SUBJECT: Forwards June 1983 semimonthly open item report.

SWEC JUNE SEMIMONTHLY REPORT

OPEN ITEM REPORT

File No. 8065

PLAN VIEW

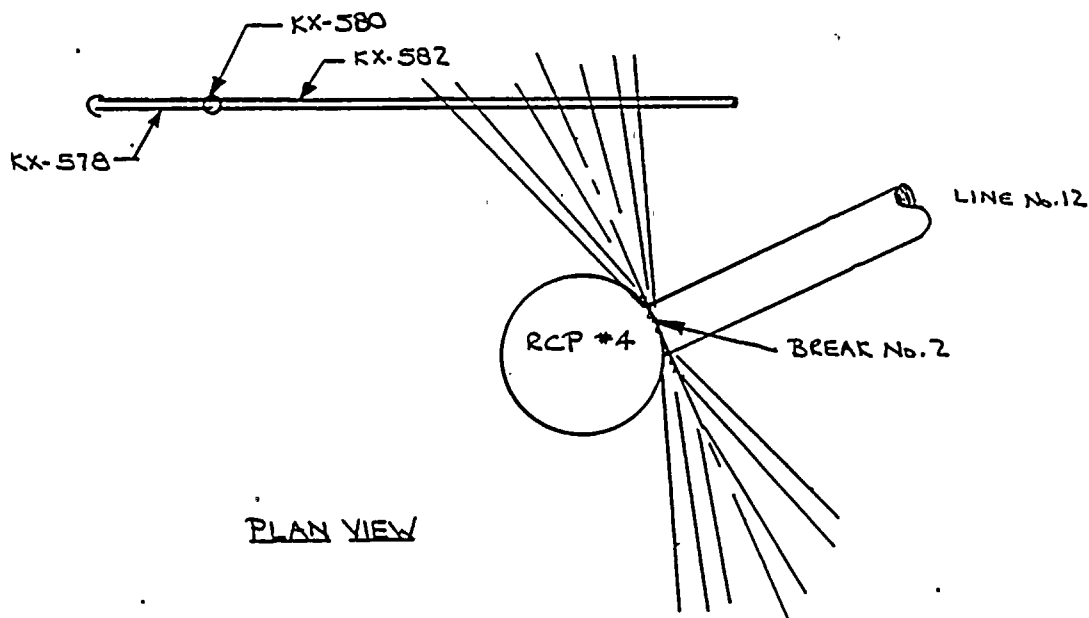
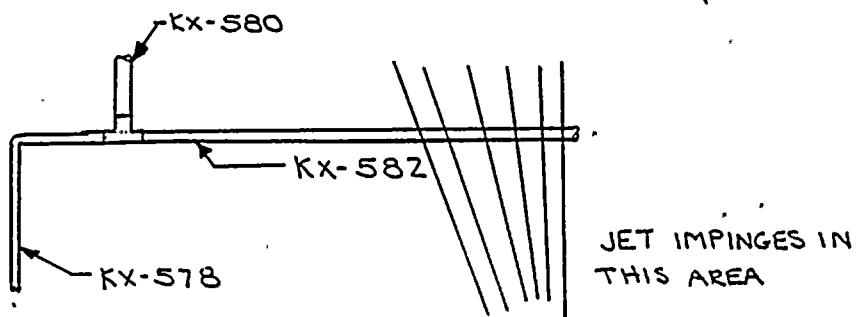
Conduit KX-582 has been misidentified as conduit KX-578. Conduit KX-578 is identified as a target on the DCP Jet Impingement Review Sheets for postulated break No. 2 at the Reactor Coolant Pump (RCP) Outlet. The IDVP field inspection, has determined that KX-578 is outside the zone of influence (Z01) for this break. Conduit KX-582 was determined to be within the Z01 but was not identified as a target on the DCP Jet Impingement Review Sheets. ---

The safety evaluation was performed for conduit KX-578 though conduit KX-582 is the affected target. Conduit KX-582 may contain different cables than conduit KX-578, which may be needed to safely shutdown the plant.

The DCP should perform a safety evaluation to determine if conduit KX-582 is needed to safely shutdown the plant for a postulated break at the RCP outlet (Break No. 2 on Line No. 12).

FIGURE 1. BREAK NO. 16 ON LINE 24. - ISOMETRIC SKETCH

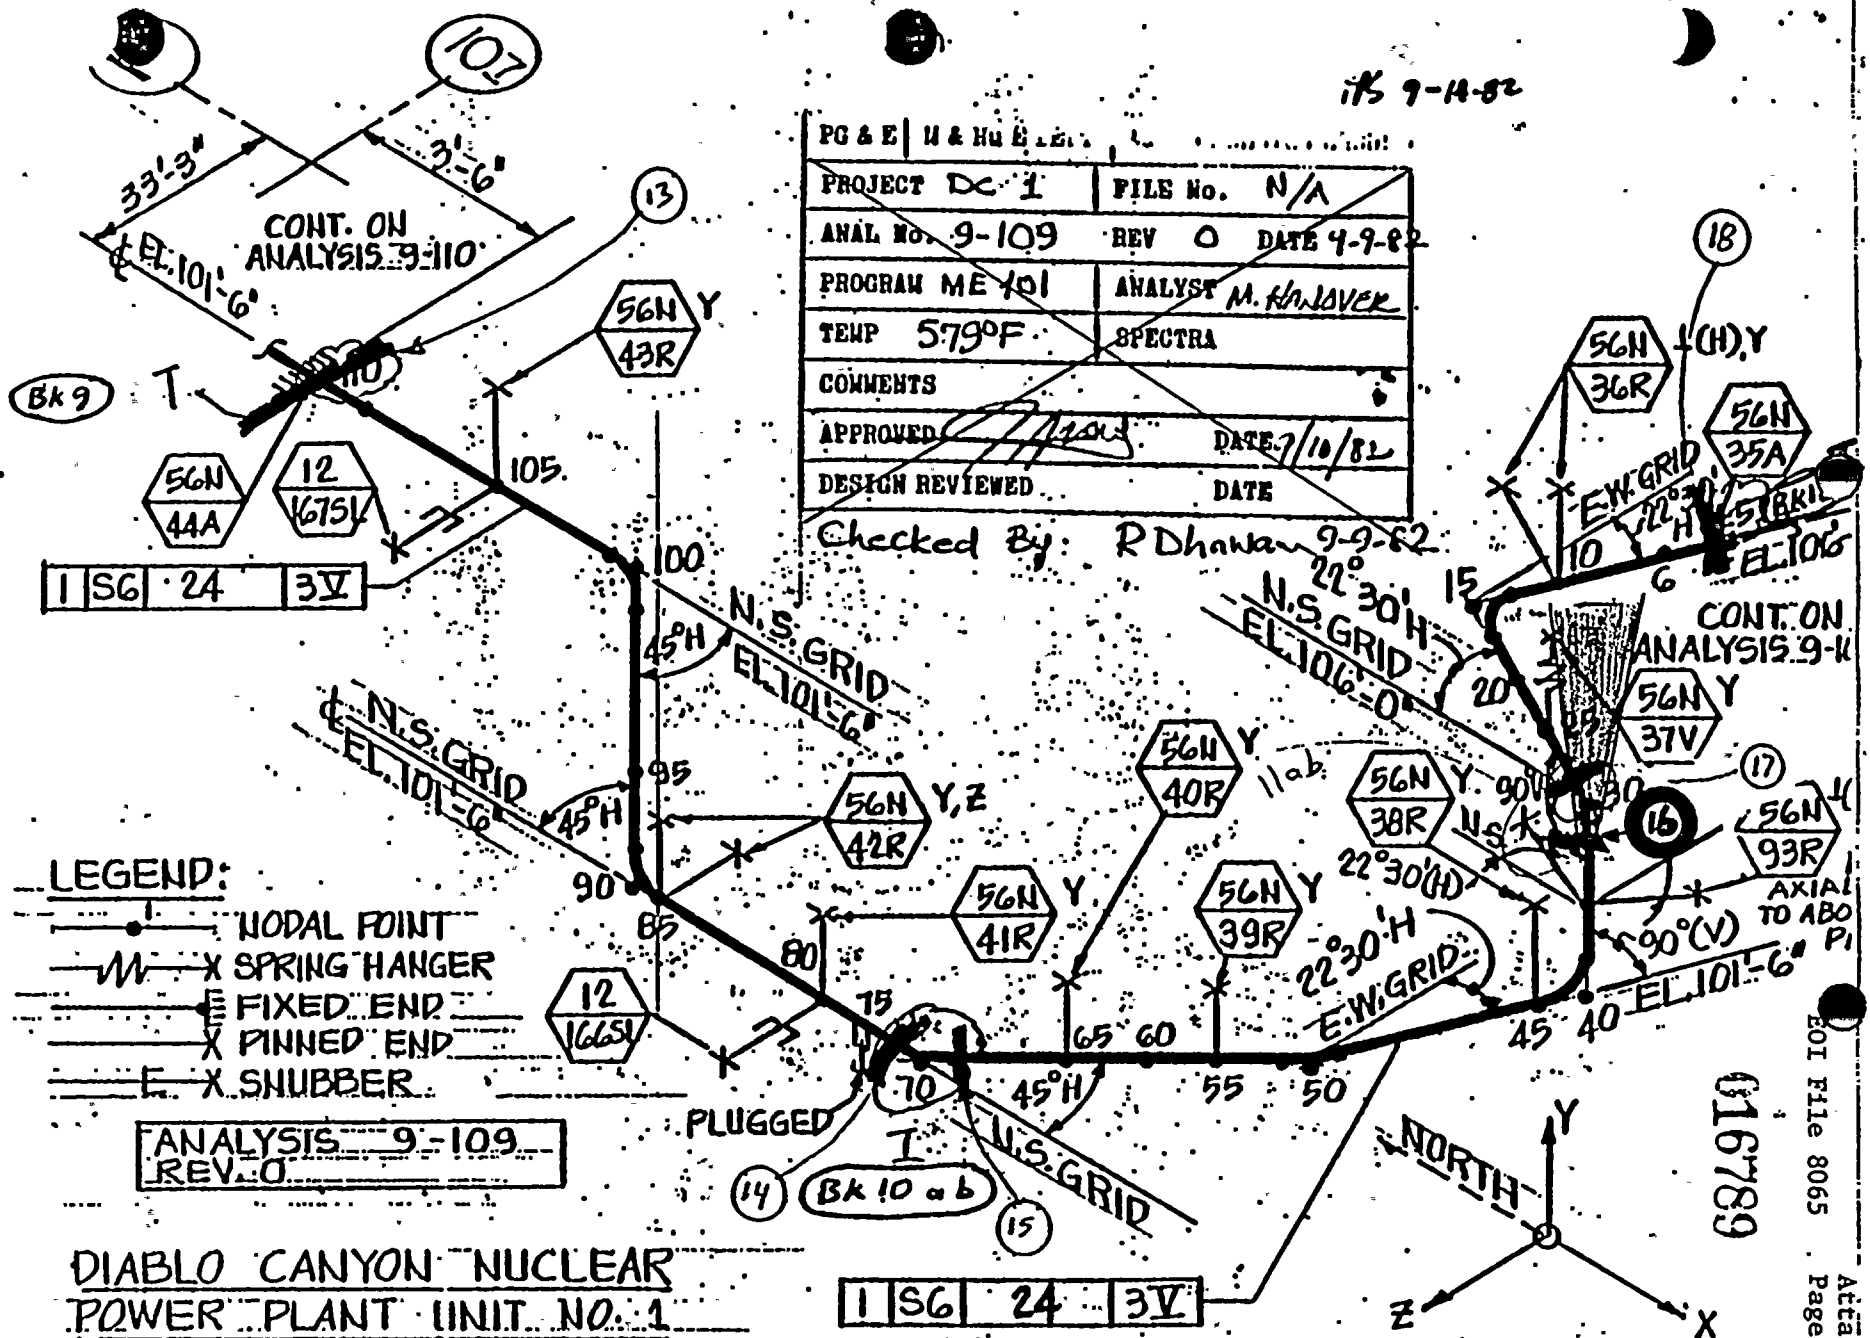
A pipe rupture on letdown line 24 at break location No. 16 (see Figure 1) results in a blowdown jet vertically upward, which impinges upon safety-related (grey) conduit KX-428 (approximately 160" above the break location). (see Figure 2)

As the conduit is color coded grey and therefore safety-related, it may contain cables which are essential for reactor shutdown under conditions resulting from postulated break 16 on line 24.

A safety evaluation should be conducted to determine if conduit KX-428 is essential for reactor shutdown under the conditions associated with the postulated pipe break 16 on line 24.

FIGURE 1. BREAK NO. 12 ON LINE 24 - ISOMETRIC SKETCH

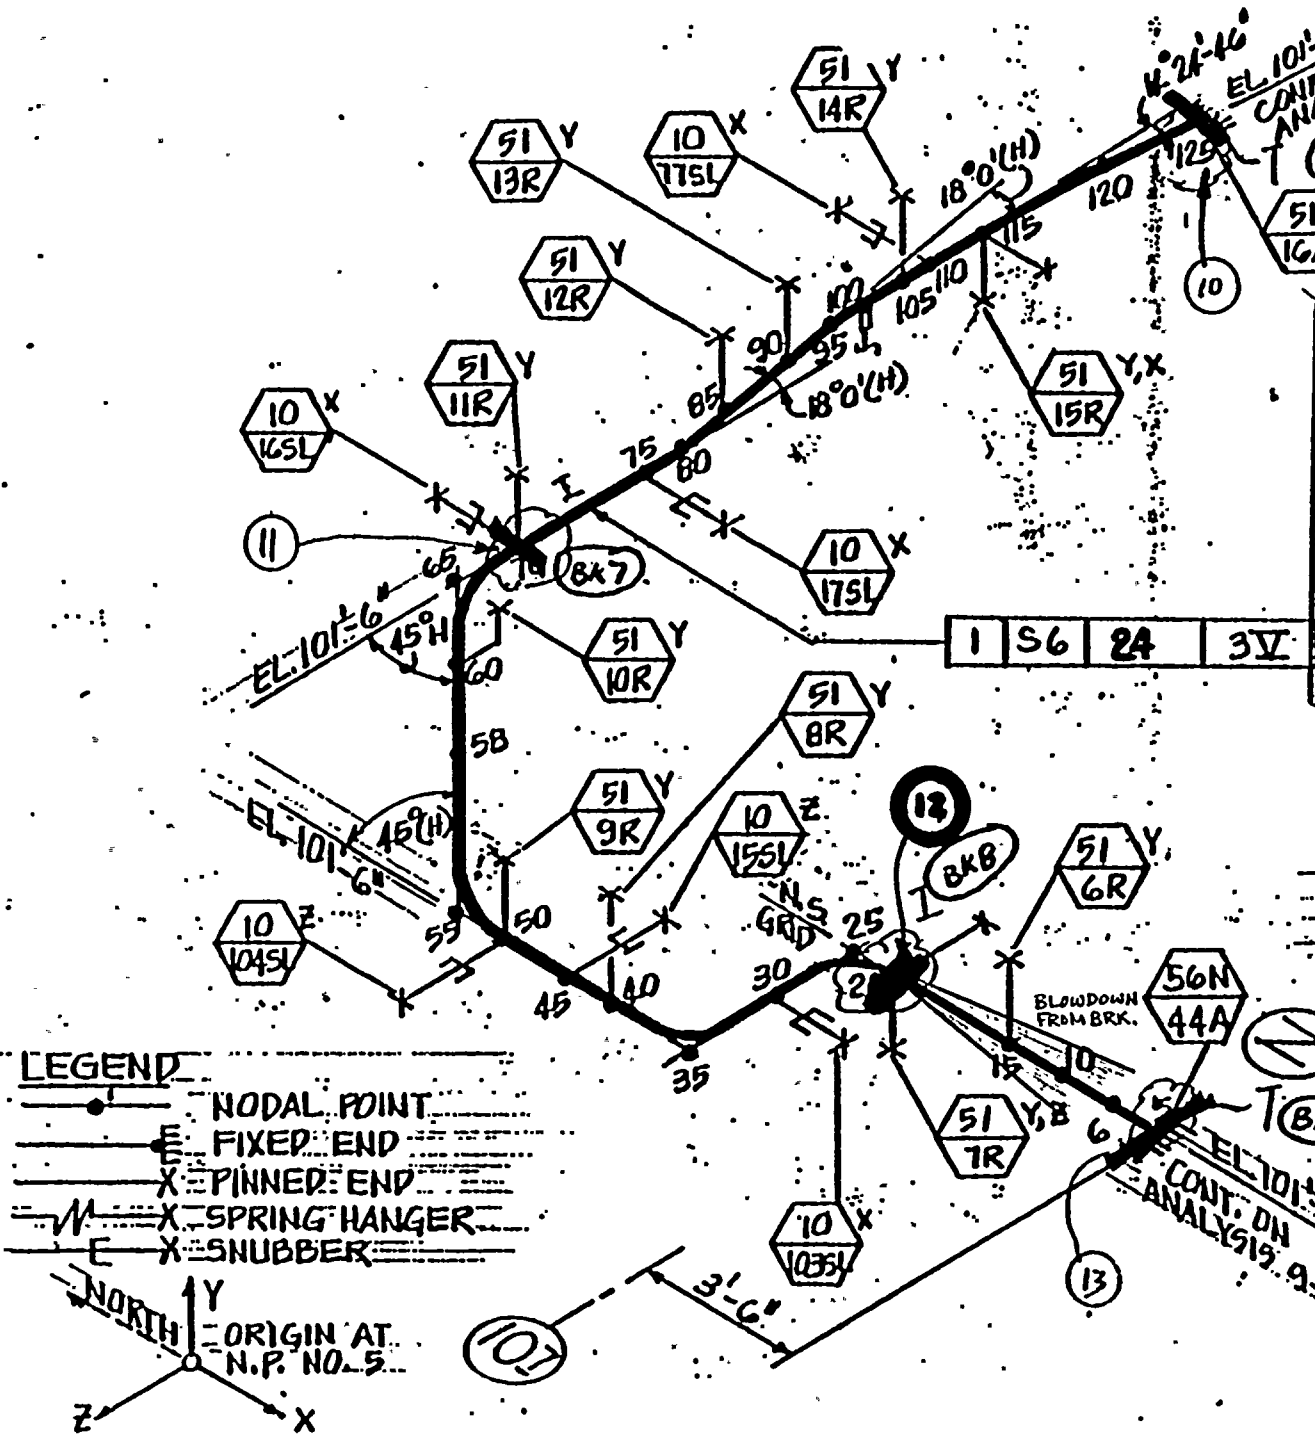
A pipe rupture on letdown line 24 at break location 12 (see Figure 1) results in a traveling jet. The traveling jet sweeps horizontally and impinges upon two of the vertical supports for the excess letdown line 63 (see Figures 2&3).

As more than one support for the safety-related line 63 is being affected by jet impingement from break 12 on line 24, the interaction may affect the stresses in line 63, such that the piping integrity may be impaired.

A safety evaluation should be conducted to determine if Excess Letdown line 63 is essential for reactor shutdown under the conditions associated with the postulated rupture of Letdown line 24, and to assure compliance with licensing commitments in FSAR Section 3.6.

FIGURE 2A

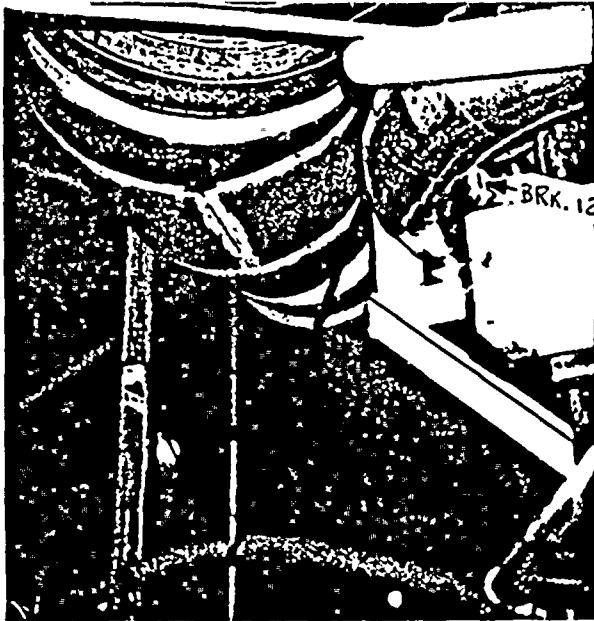
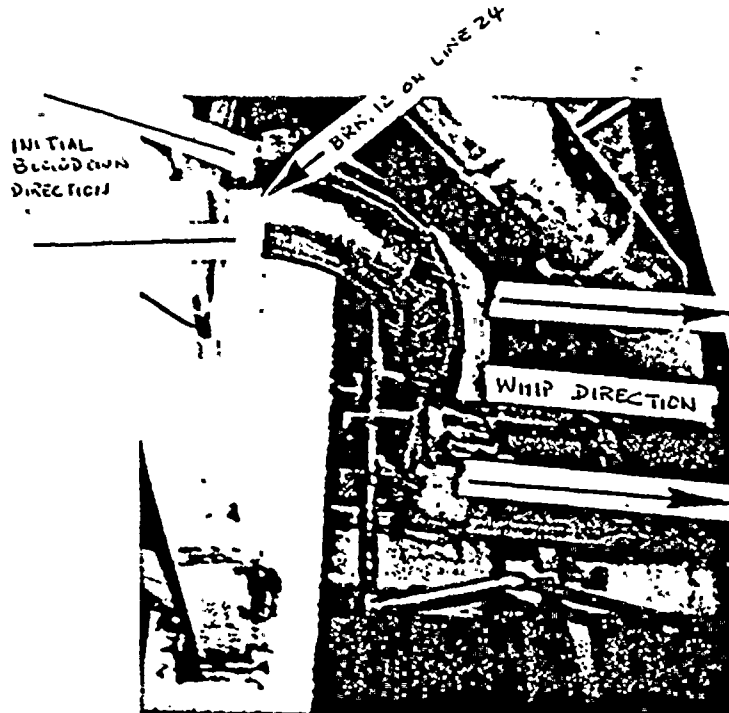
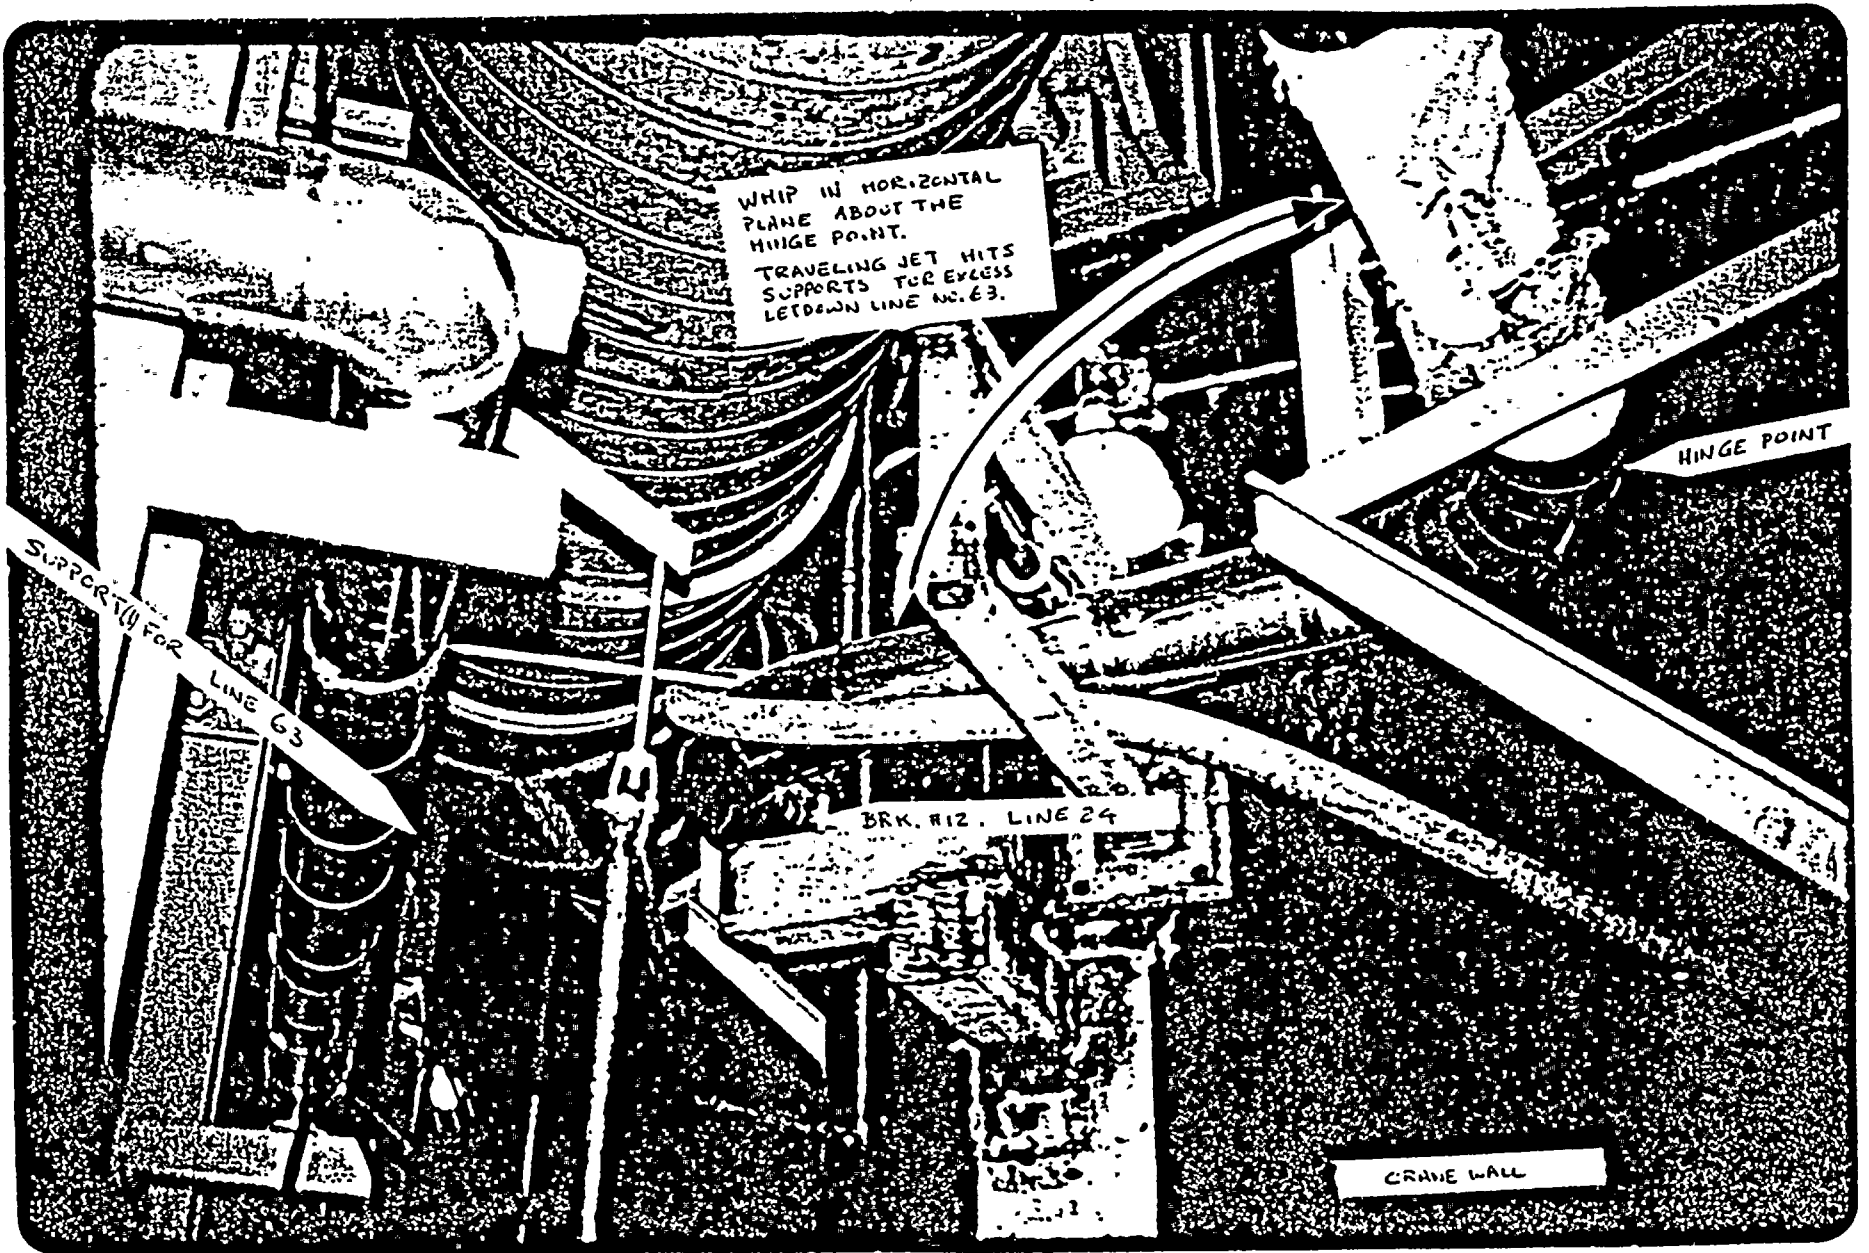
2 SUPPORTS ARE IMPINGED UPON BY TRAVELING JET FROM BREAK 12 ON LINE 24 AS THE LINE WHIPS

↑
SUPPORT (2) FOR LINE 63
(TOO DARK TO SEE ON PHOTO)
